Access Compliance Report

Public Rights-of-Way

Intersection ID: 42535	Main Street: BALTINGLASS_CT	Cross Street: CASTLETOWN_HOUSE_DR	Location: NE
ADA ID: 83DA84858D45	Ramp Type: BlendTrans1	Initial Pass/Fail: Fail	Overall Compliance: No
		Severity Score: 12.5

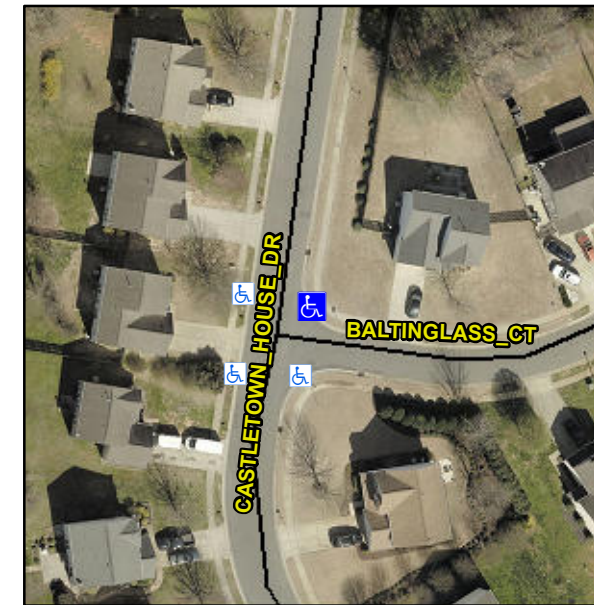
Not Found, R304.5.3

Compliance	Description	Data	Compliance	Description	Data
N/A	Ramp Length (in)	46.5	Yes	BlendTrans Slope (%)	3.6
Yes	Ramp Width (in)	49.0	No	BlendTrans XSlope (%)	5.1
N/A	Flare Type LT	N/A	N/A	Flare Type RT	N/A
N/A	Flare Slope LT (%)	N/A	N/A	Flare Slope RT (%)	N/A
N/A	Flare Traversable LT?	N/A	N/A	Flare Traversable RT?	N/A
N/A	Landing Length (in)	N/A	N/A	DWS Provided?	N/A
N/A	Landing Width (in)	N/A	N/A	DWS Contrast?	N/A
N/A	Landing Slope (%)	N/A	N/A	DWS Length (in)	N/A
N/A	Landing X Slope (%)	N/A	N/A	DWS Full Width?	N/A
N/A	Landing Curb? (Y/N)	N/A	N/A	DWS Offset (in)	N/A
N/A	Shared Landing?	N/A			
N/A	Gutter Ponding?	N/A	N/A	Gutter Slope (%)	N/A
N/A	Gutter Lip Ht (in)	N/A	N/A	Gutter X Slope (%)	N/A
N/A	Painted X Walk1?	No	N/A	Painted X Walk2?	No
	X Walk 1 Direction	To W		X Walk 2 Direction	To S
	X Walk 1 Width (in)	N/A		X Walk 2 Width (in)	N/A
	X Walk 1 Slope (%)	5.0		X Walk 2 Slope (%)	2.9
	X Walk 1 X Slope (%)	3.8		X Walk 2 X Slope (%)	3.3

N/A	Ramp inside XWalk1?	N/A	N/A	Ramp inside XWalk2?	N/A
	Road Slope (%)	3.8		Clear Space?	N/A
	Road X Slope (%)	6.2	N/A	Clear Space to XWalk (in)	N/A
N/A	Any Obstructions?	N/A	N/A	Storm Grate/Utility Hazard?	N/A
	Obstruction Type			Storm Grate/Utility Type	
		N/A			N/A
			Yes	Surface Condition? (G/P)	Good
			No	Curb Slope (%)	7.6

Remove & Replace Curb Ramp With Two New Directional Ramps or Equivalent.
